**To:** Sam Hubbard, Development Planner, Planning and Community Development  
**From:** Deb Pierce, Plan Reviewer, Building Services Department  
**Subject:** Windsor Elementary School, 1315 E. Miner St., Amendment to Ordinance #90-082, Parking Variation, Setback Variation and Impervious Surface Variation  
**PC #:** 16-026 – Round 1  
**Date:** December 8, 2016

**PLAN COMMISSION PC #16-026  
Windsor School Addition  
1315 E. Miner Street  
Amendment to Ord#90-082; Parking Variation;  
Setback Variation; Impervious Surface Variation  
Round 1**

Project: 1315 E. Miner Street – School District 25  
Windsor Elementary School

# FIRE ENGINE TURNING TEMPLATE

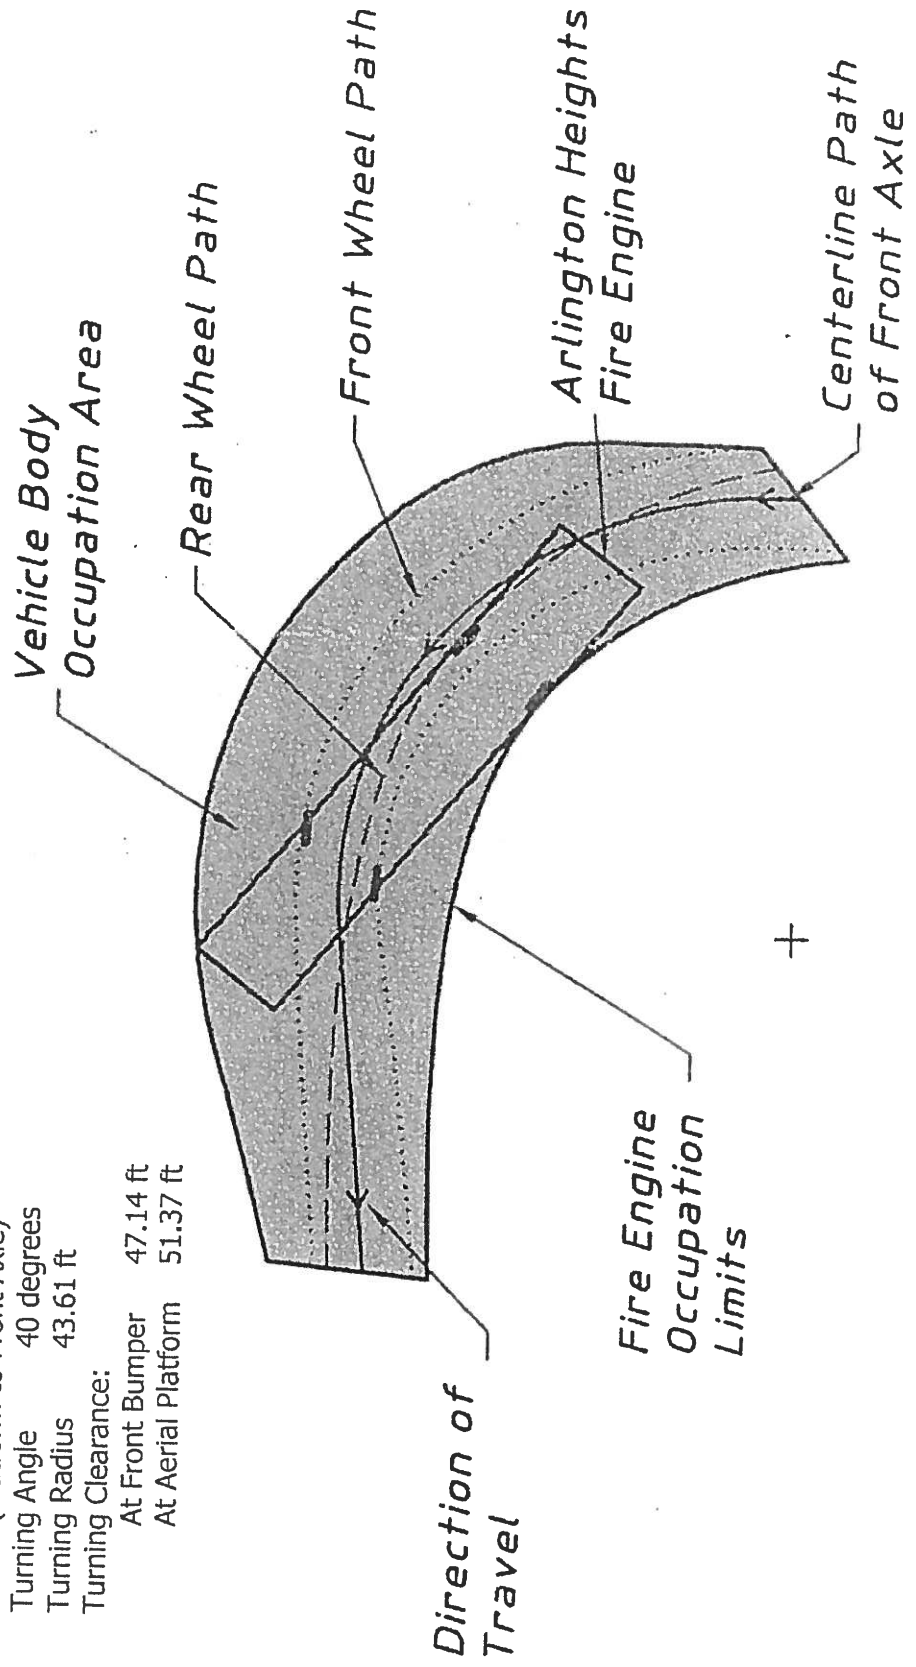
17. Provide an exhibit to engineering scale showing the turning path of the Fire Department's responding vehicle, in this case the tower truck. Exhibit must show front and rear wheel paths and the extent of the front and rear overhangs, as provided in an "Autoturn" exhibit. The vehicle shall be shown maneuvering through the site in all possible directions of travel. Attached are the specifications for the tower apparatus.
